June 11, 2021

Subject: ITB #1914-B: Crosstown and South Fayette Water Treatment Plants Hoseless Solids Collections System Addendum #1

0330-144

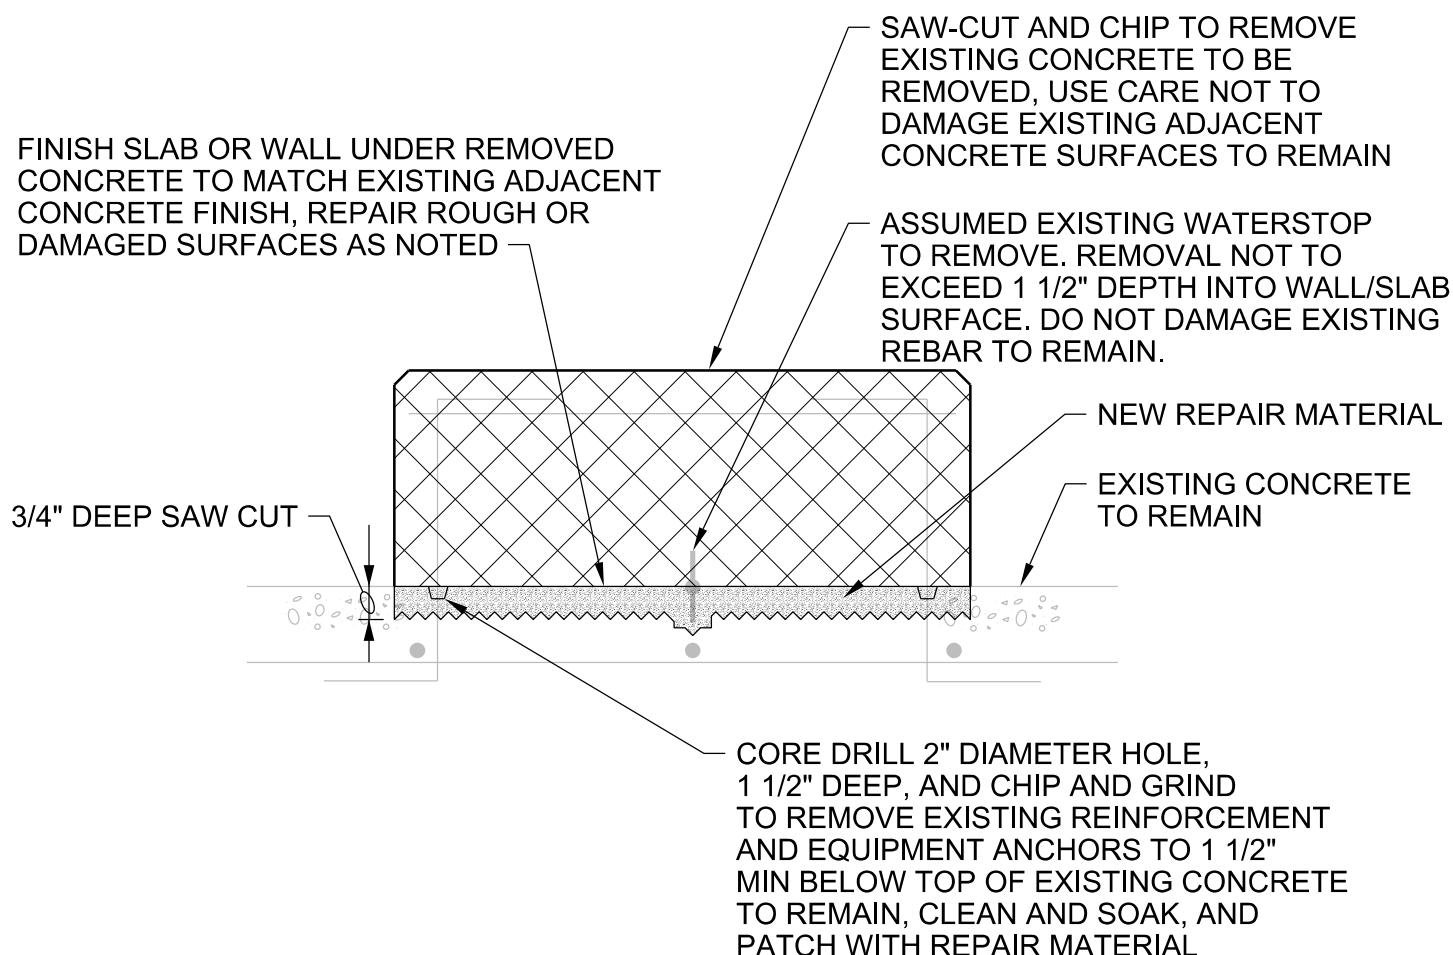
Drawing SF-10-M-103:

Section A – Change the Detail callout from 'XXXX-XXX' to '0330-144'.

Drawing 99-M-501:

ADD Detail 0330-144, attached.
